Re: Source Materials License SUA-1534
Docket No. 40-8943
Mine Unit 1 Restoration; Response to Request For Additional Information

**Crow Butte Resources, Inc.
Response to U.S. Nuclear Regulatory Commission
Request For Additional Information**

Mine Unit 1 Groundwater Restoration Completion

Crow Butte Uranium Project

Appendix A. Stabilization Trends for Selected Parameters

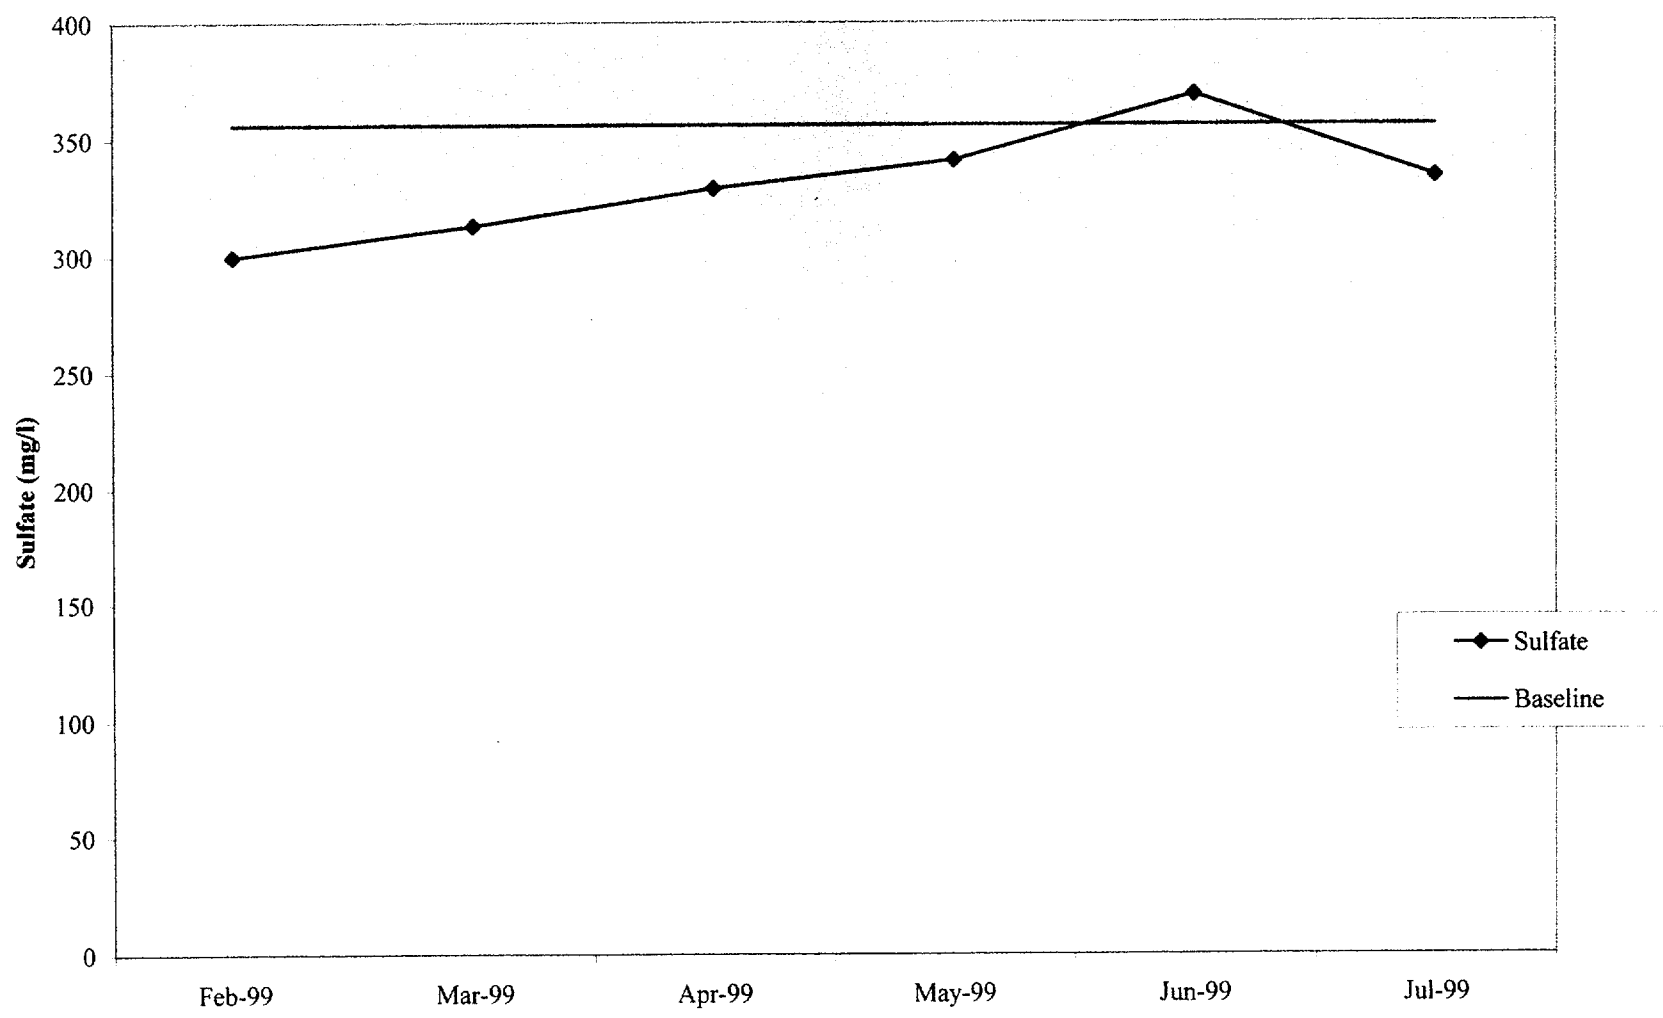
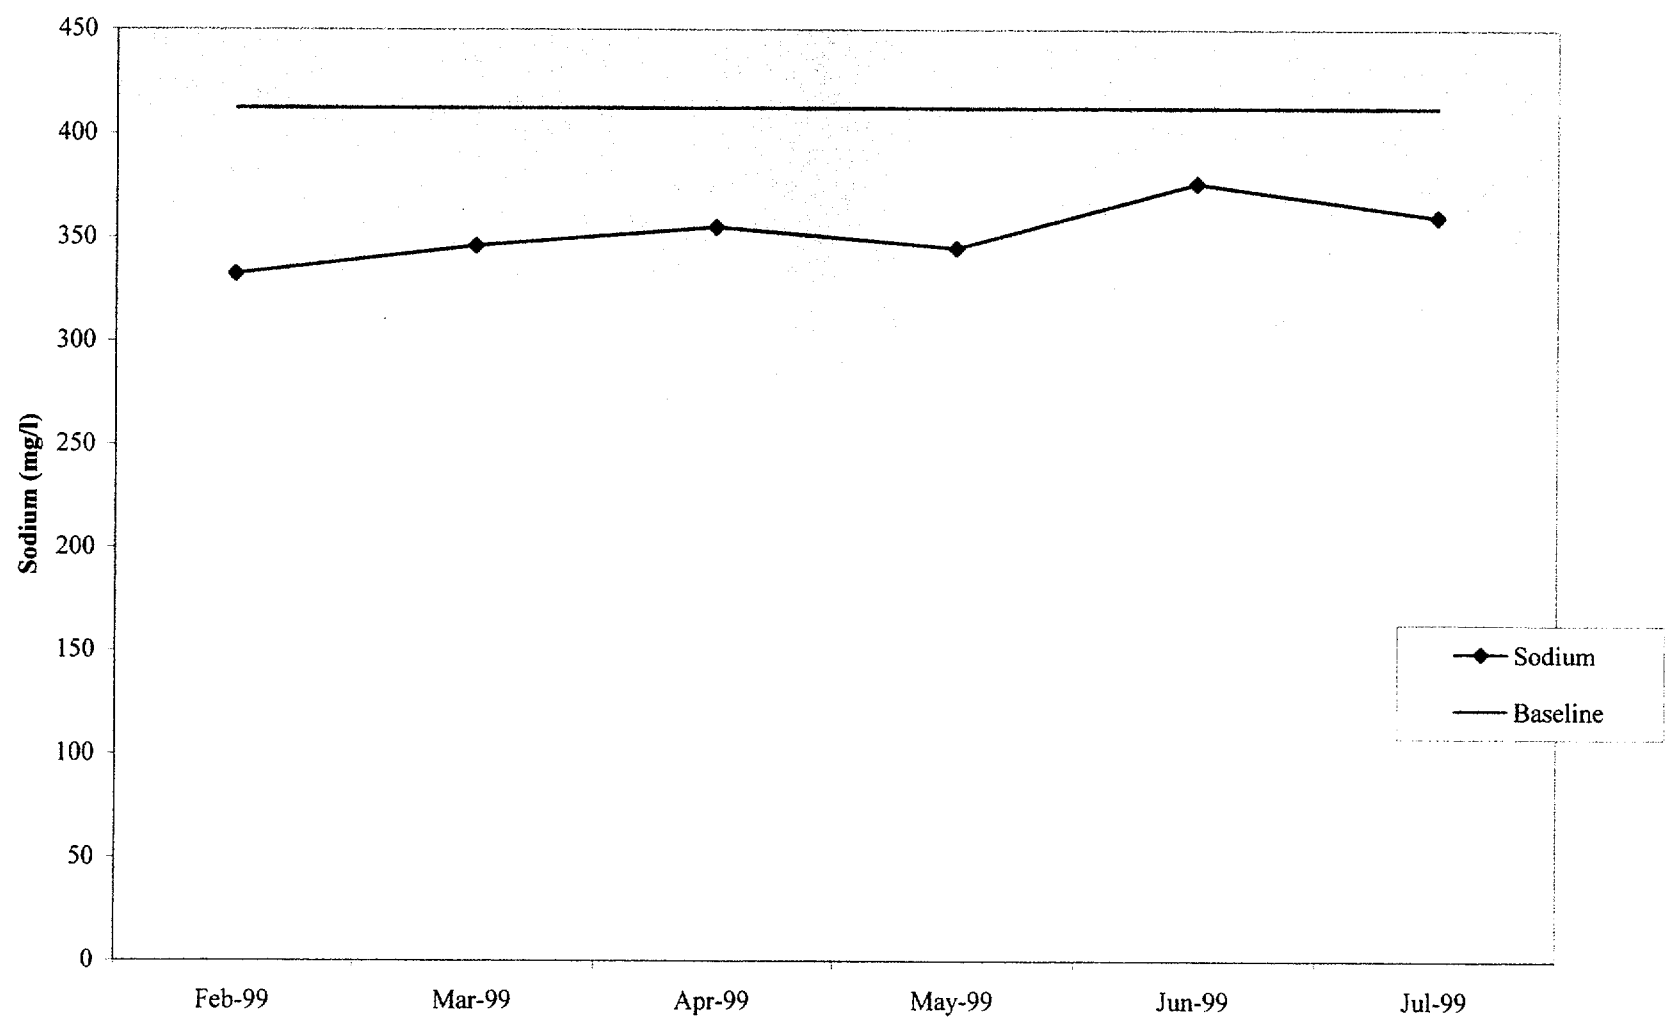
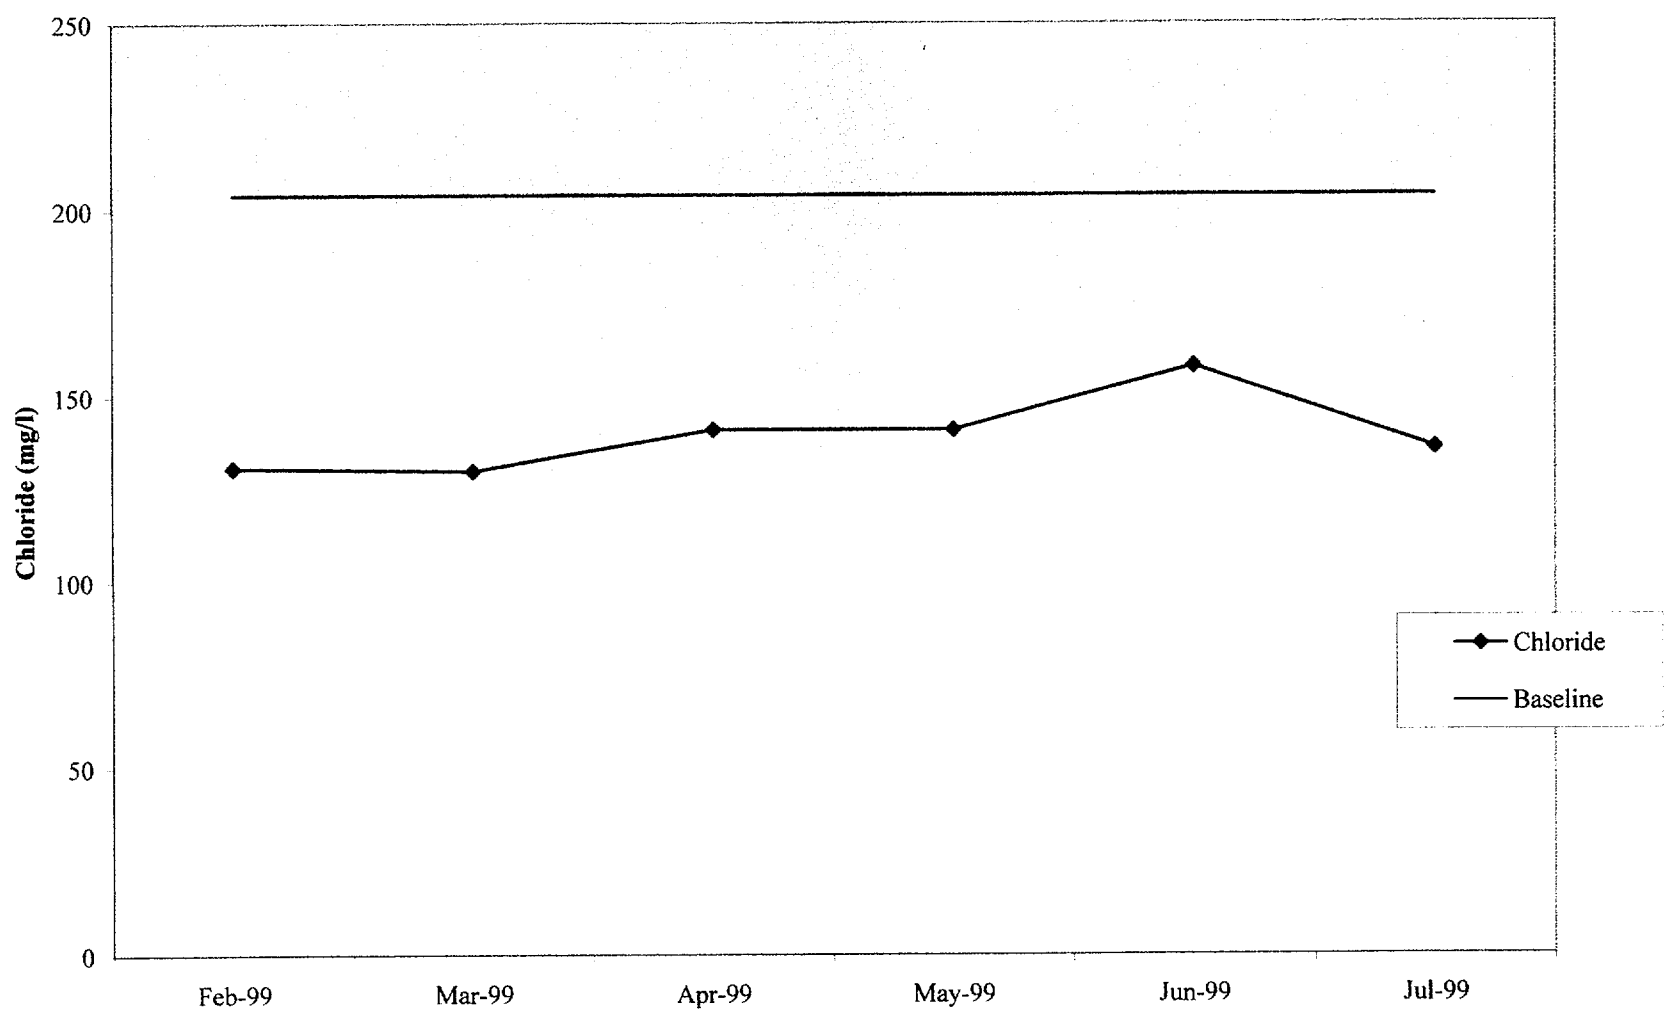
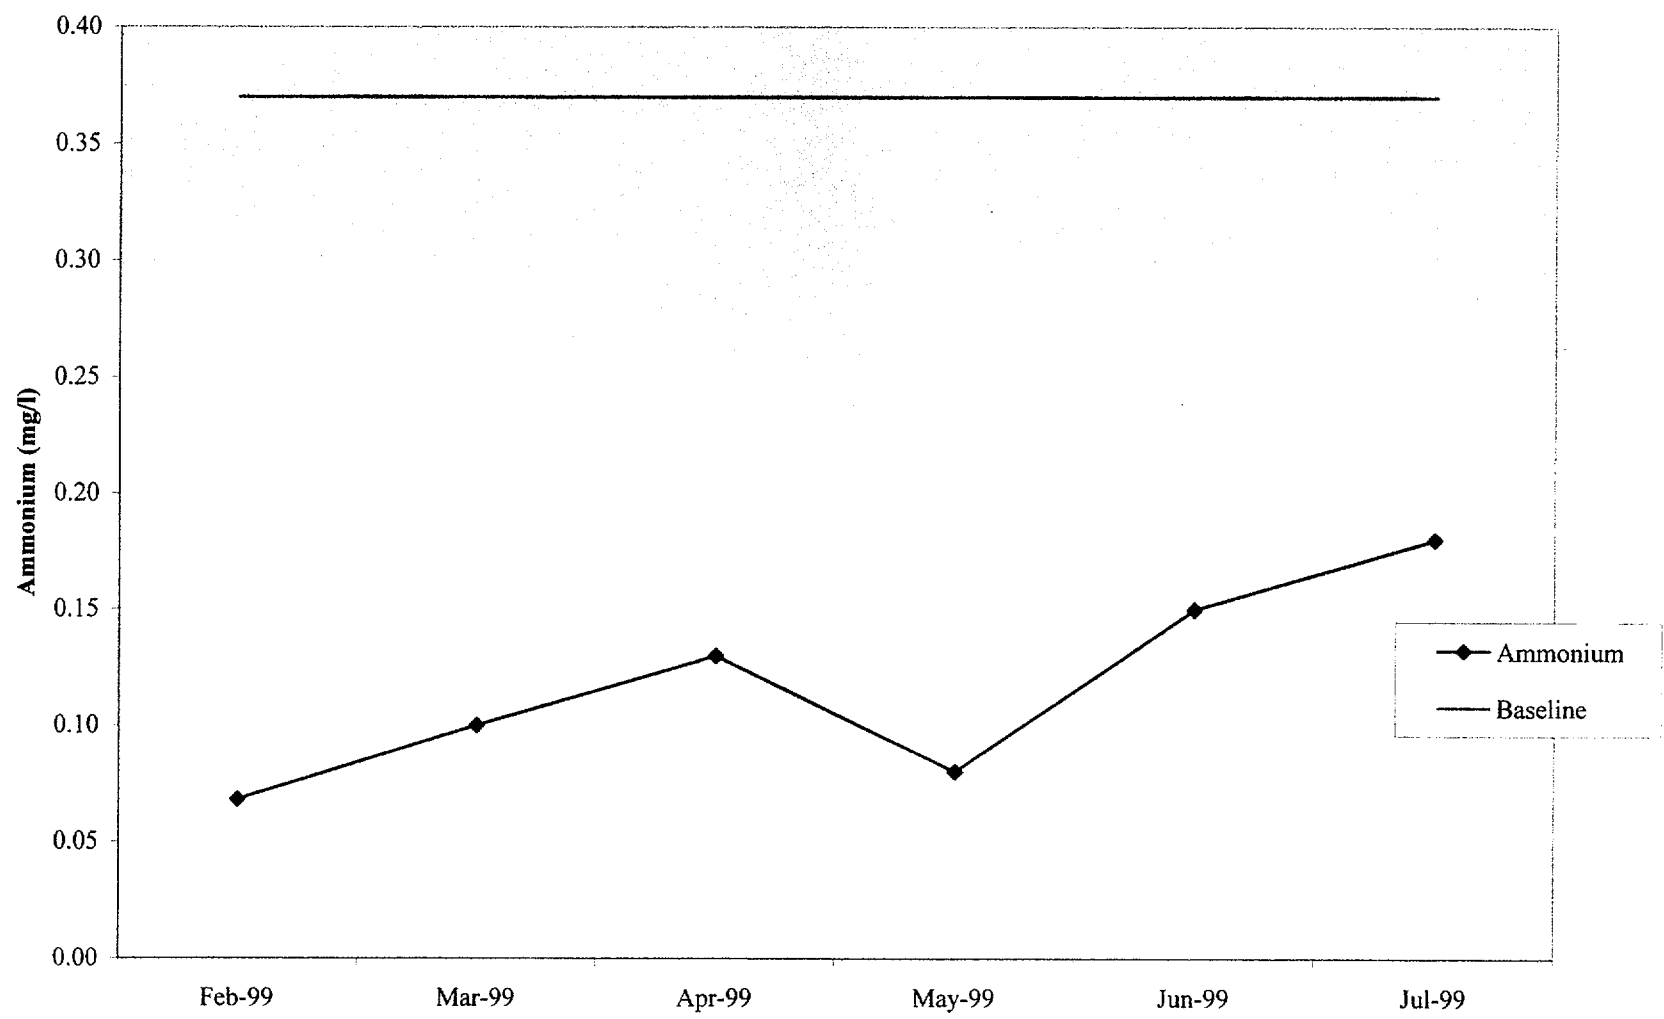
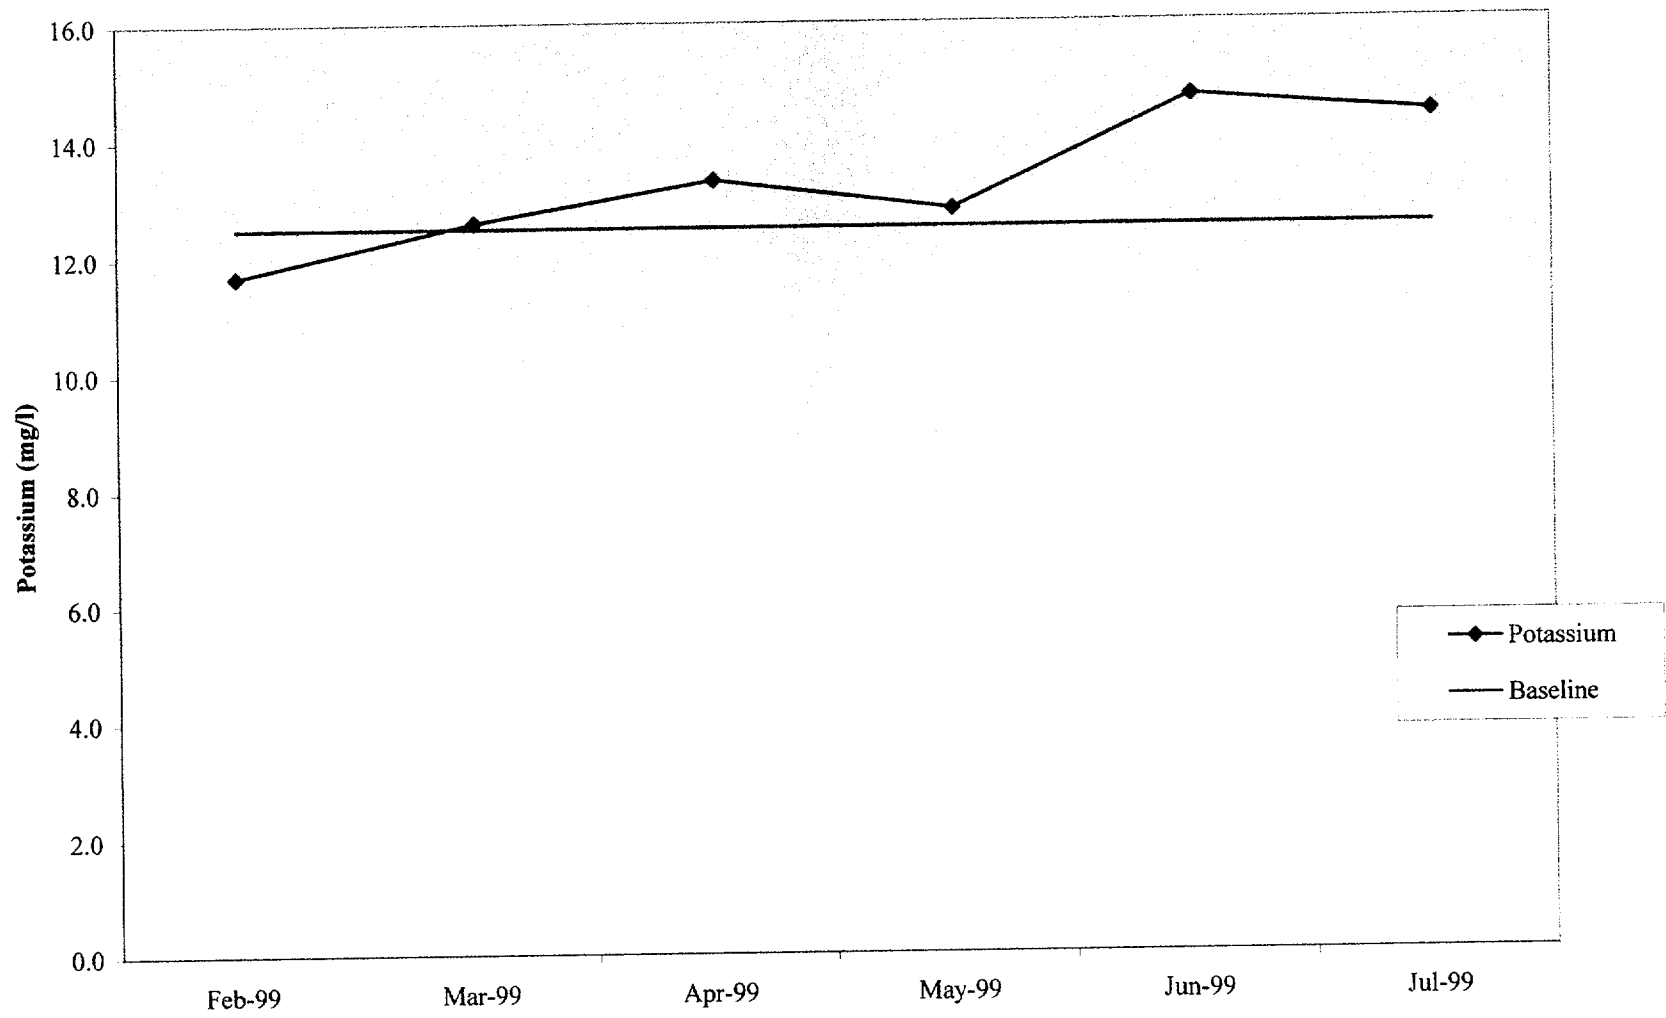
The NRC noted "strongly increasing" trends in a number of restoration parameters during the six month stabilization period. Specifically, NRC noted increasing trends in uranium, carbonate, potassium, radium-226, calcium, ammonium, chloride, iron, magnesium, manganese, molybdenum, sodium, sulfate, and total dissolved solids. In NRC's opinion, these trends could indicate that Mine Unit 1 was not stable during the stabilization monitoring period. NRC requested the following information to support CBR's position that Mine Unit 1 is stable.

Appendix A contains trend graphs from the stabilization period for all fourteen parameters identified by NRC. The graphs include a reference line for the average baseline concentration of the parameter. A review of these graphs indicates that most parameters do not exhibit a significant increasing trend, particularly when the final sample results are considered. Of the fourteen parameters listed by NRC, eleven showed no change or a significant decrease in the final stabilization sample. Only three parameters (ammonia, iron and magnesium) exhibited an increasing trend throughout the stabilization period.

- Ammonia was restored to concentrations below baseline. The final sample was 0.18 mg/l, or approximately 50 percent of the baseline concentration of 0.37 mg/l. It should be expected that ammonia concentrations would increase until natural background concentrations are restored.

- Iron exhibits a strong trend throughout the stabilization period, increasing from 0.049 to 0.127 mg/l. However, restoration successfully reduced iron to concentrations well below the secondary restoration goal. The final sample was 0.127 mg/l, or 42 percent of the restoration standard of 0.30 mg/l, which is based on the EPA Secondary Drinking Water Regulations (SDWR).
- Magnesium increased from 4.3 to 6.1 mg/l during the stabilization period. However, restoration successfully reduced magnesium to concentrations well below the secondary restoration goal. The final sample was 6.1 mg/l, or 19 percent of the restoration standard of 32 mg/l. Note that there are no EPA or NDEQ numerical standards for magnesium. The restoration standard is based upon one order of magnitude above baseline concentrations due to the ability of some major ions to vary with pH.
